# HICKORY CREEK ESTATES

RE: S/D 95-60 - Final Plat of Hickory Creek Addition

RE: S/D 95-60 - Final Plat of Hickory Creek Addition

S/D 95 - 60 - Hickory Creek Estates Final Plat

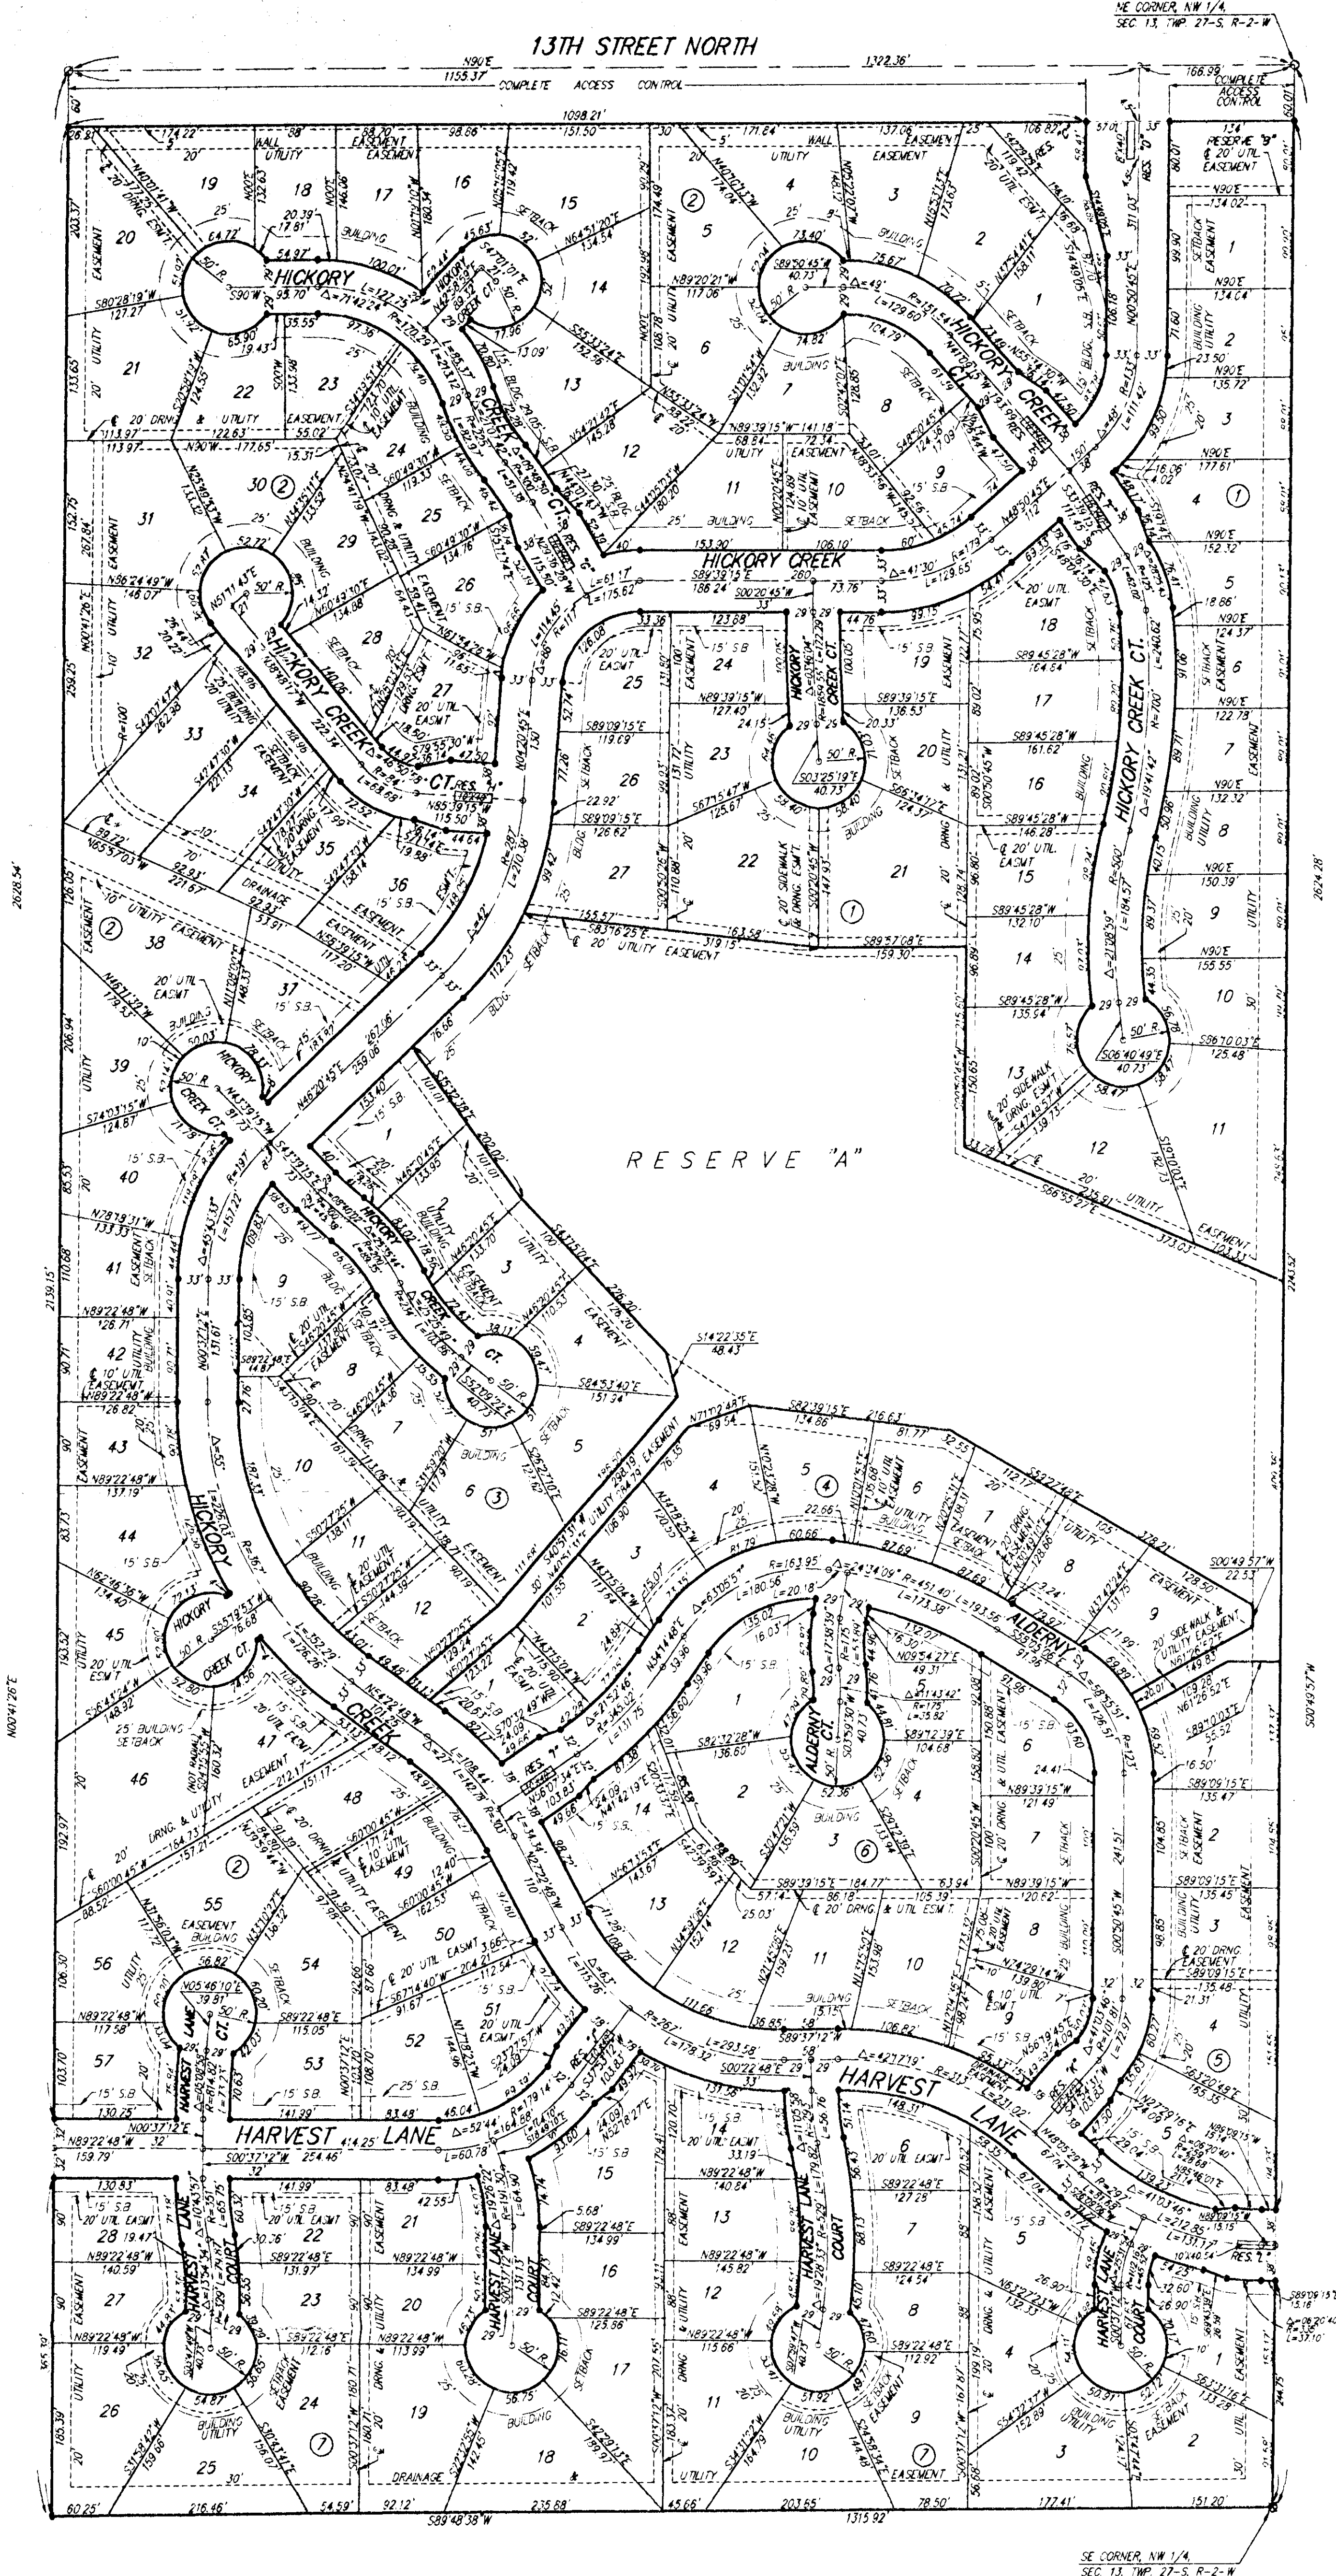
- A. Prior to this plat being forwarded to the Wichita City Council for approval, this site will need to have been annexed to Wichita. Upon annexation, this property will be zoned City "AA" one-family and will allow the lot sizes being platted.

- B. The applicant shall guarantee the extension of sanitary sewer to serve the lots being platted. The applicant shall also submit calculations needed to determine the capacity of a lift station needed to serve this site. If determined necessary by City Engineering, guarantees shall also be provided for any needed improvements to this lift station.

- C. The applicant shall guarantee the extension of City water to serve the lots being platted. This guarantee shall also provide for the extension of water across this site's frontage to 13th Street North.

- D. The applicant shall guarantee the paving of the proposed interior streets. This guarantee shall also provide for sidewalks. As a collector street, sidewalk is required along both sides of Hickory Creek/Azure. Sidewalks shall also be provided along one side of the section of Azure which extends westward into the abutting property.

While the need for sidewalks on both sides of a collector is typically considered essential because of concerns with safety, this plat's design involving a large Reserve, access easements or extensions of the Reserve and other streets paralleling the collector street suggests that one portion of the required collector sidewalks could be routed along an alternative path. If the applicant desires, an alternative sidewalk should be provided for consideration. That is, a sidewalk along one-side of the collector would still be required with the second section of sidewalk potentially following an alternate route; providing that

such alternate route basically supplements the collector's alignment.

- E. As requested by City Engineering, the applicant shall provide appropriate guarantees to participate in the paving of 13th Street North adjacent to this site.

- F. The applicant shall guarantee any drainage improvements required by the platting of this property. As requested by City Engineering, additional drainage information is needed before the drainage plan can be approved. Also any additional easements or widening of drainage easements determined necessary shall be provided for on the final plat tracing.

- G. The applicant shall guarantee construction of the storm sewers required by this plat.
- H. If improvements are guaranteed by petition, a notarized certificate listing the petitions shall be submitted to the Planning Department for recording.

- I. Provisions shall be made for ownership and maintenance of the proposed reserves. The applicant shall either form a lot owners' association prior to recording the plat or shall submit a covenant stating when the association will be formed, when the reserves will be deeded to the association and who is to own and maintain the reserves prior to the association taking over those responsibilities. Further, this covenant shall provide for the homeowners' association to maintain the "parking strip" area located between this plat's north line and the driving surface for 13th Street North.

Since a swimming pool and related facilities are planned as a use to be located in one of the Reserves, a site plan as specified in the Subdivision Regulations must be submitted to Planning for review and approval.

- J. For those reserves being platted for drainage purposes, the required covenant which provides for ownership and maintenance of the reserves shall grant, to the City, the authority to maintain the drainage reserves in the event the owner(s) fail to do so. The covenant shall provide for the cost of such maintenance to be charged back to the owner(s) by a method similar to special assessments.

- K. The applicant shall submit a covenant which provides for four (4) off-street parking spaces per dwelling unit on each lot which abuts a 58-foot street. The covenant shall inventory the affected lots by lot and block number and shall state that the covenant runs with the land and is binding on future owners and assigns.

- L. The final plat tracing shall indicate on the face of the plat complete access control to 13th Street North from the adjacent lots and Reserves (D & C).

- M. It is recommended that the improvements (walks) for the pedestrian access easements be provided at the time of site development by the developer. Maintenance of the walks and easements should also be specified in this Addition's covenants.

- N. The applicant shall install or guarantee the installation of all utilities and facilities which are

applicable and described in Article 8 of the MAPC Subdivision Regulations. (Water service and fire hydrants required by Article 8 for fire protection shall be as per the direction and approval of the Chief of the Fire Department.)

- R. Prior to this plat being released for recording, the applicant shall provide proof that ownership of the property is vested in the party signing the plat as the platfor. The platting binder presently indicates ownership in a different party.

- S. Perimeter closure computations shall be submitted with the final plat tracing. Section 5-101(c).
- T. Recording of the plat within 30 days after approval by the City Council.

- U. The final plat shall indicate the utility easements requested by K.G.& E. which are indicated on the enclosed "marked" copy of the plat.
